**Subject:** HGA Relay Armature Binding

**Reference:** GE Relay Service Advice Letter (SAL) 516.1, "HGA Armature Binding," October 25, 1996.

### **RELAY SERVICE ADVICE LETTER**

Number: 516.1  
Date: 10/25/96

FIGURE 1

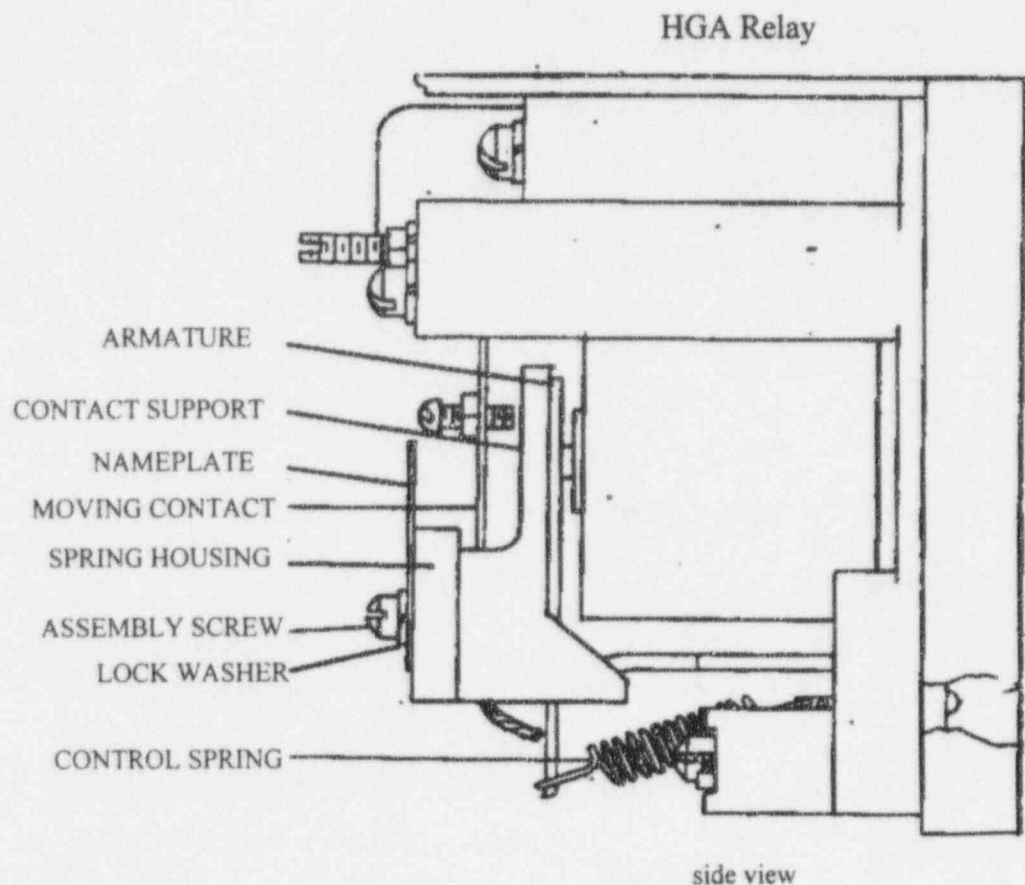
1. De-energize the relay, coil and contacts.
2. Close the armature fully by hand, (push armature against the pole, see Fig. 1), and gradually release. For correct operation, the armature should move to the fully open position with no binding and with correct contact action. The normally open contacts should open and the normally closed contacts should close. If binding is detected, we recommend the following:

The contact support should be replaced as follows: (Refer to Fig. 1)

1. Disengage the control spring from the armature end. (Note the groove location of the spring hook on the armature).
2. Remove the assembly screw with its lockwasher.

3. Remove the nameplate and spring housing assembly.
4. Remove the moving contacts from the contact support and note their location for correct reassembly.

5. Remove the contact support.
6. Install the new contact support. Make sure the armature is seated properly in the contact support.
7. Locate the moving contacts in the contact support.

8. Install the nameplate and spring housing assembly.
9. Tighten the assembly screw and lockwasher (16 in-lbs. approx.). Hold contact support and spring housing assembly together while tightening assembly screw.

10. Engage the control spring on the same groove on the armature of the relay.
11. Operate the armature of the relay by hand to make sure that there is no binding.
